Fast Prototyping Board for RA2E1 Microcontroller
Group
FPB-RA2E1 v1
Errata

Renesas RA Family
RA2 Series

FPB-RA2E1 v1 – Errata

Figure 1. MCU Pin Header J3 Pin 32 Silkscreen Error

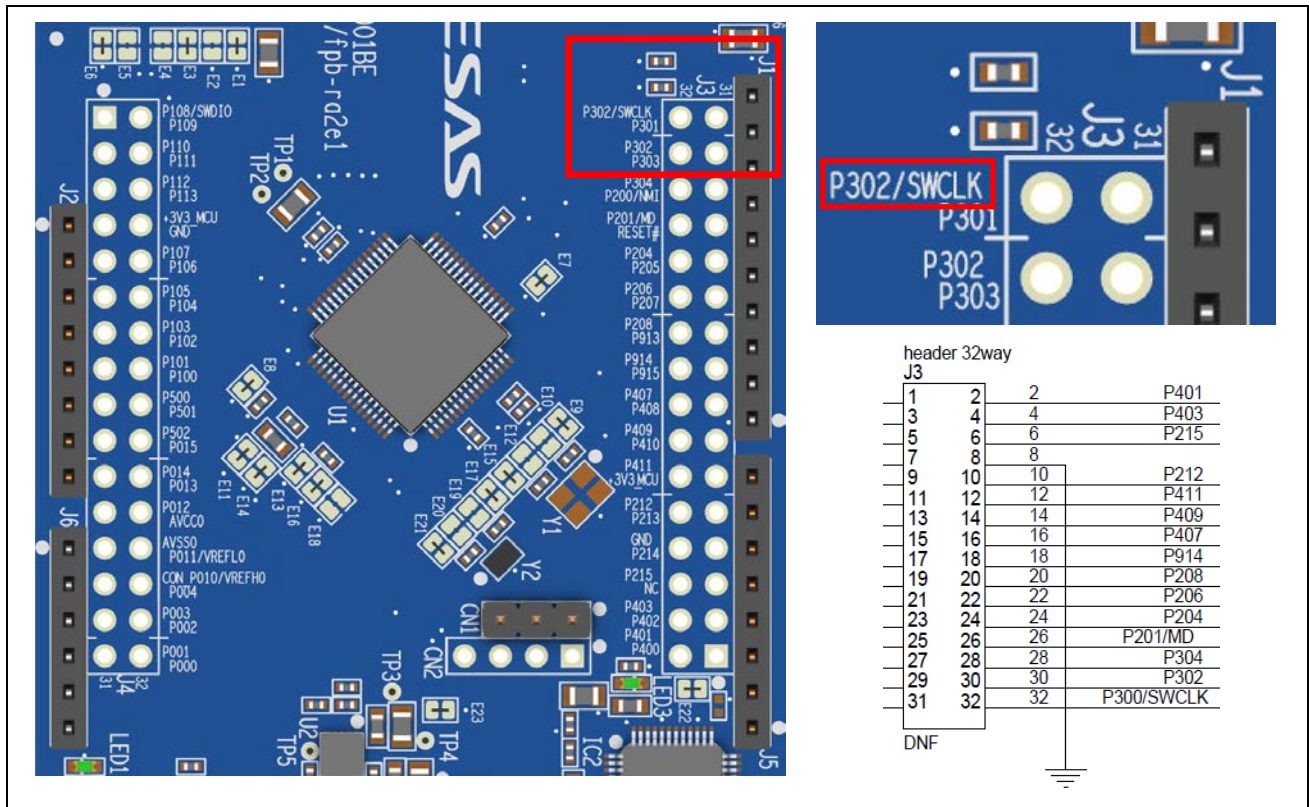
The MCU Pin Header J3 has an incorrect label for pin 32. This is identified as P302/SWCLK when it should be P300/SWCLK. The schematic is correct.

None. The silkscreen has been corrected to show the correct pin identification on later builds of the board.

Figure 2. E27 and CN3 on FPB-RA2E1

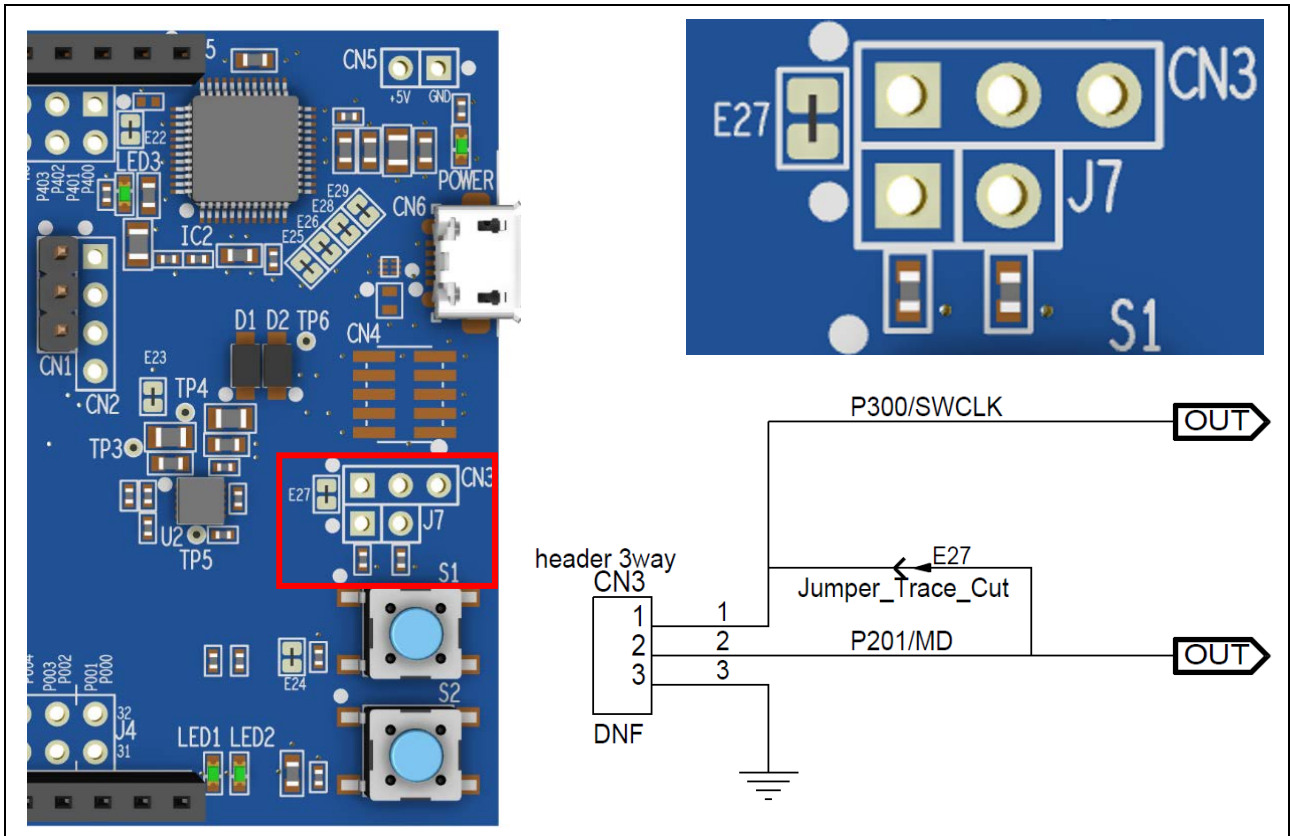
The following error has been reported when debugging:

Error 0x00030108: Rewriting of the MCU's internal flash ROM was not normally executed due to access violation to the MCU's internal flash ROM.

This has been identified as a hardware issue. To fix this error, cut trace-cut jumper E27, disconnecting P300/SWCLK from P201/MD. **This will disable the SCI boot selection option.** To re-enable SCI boot selection, pins 1-2 of CN3 must be connected. Jumper CN3 is not fitted to the FPB-RA2E1, [Wuerth Elektronik MPN: 613 003 111 21](http://www.wuerth-elektronik.com) is recommended to fit if required.

Further developments include improving the emulator firmware to allow P300/SWCLK and P201/MD to be connected without receiving the error message.
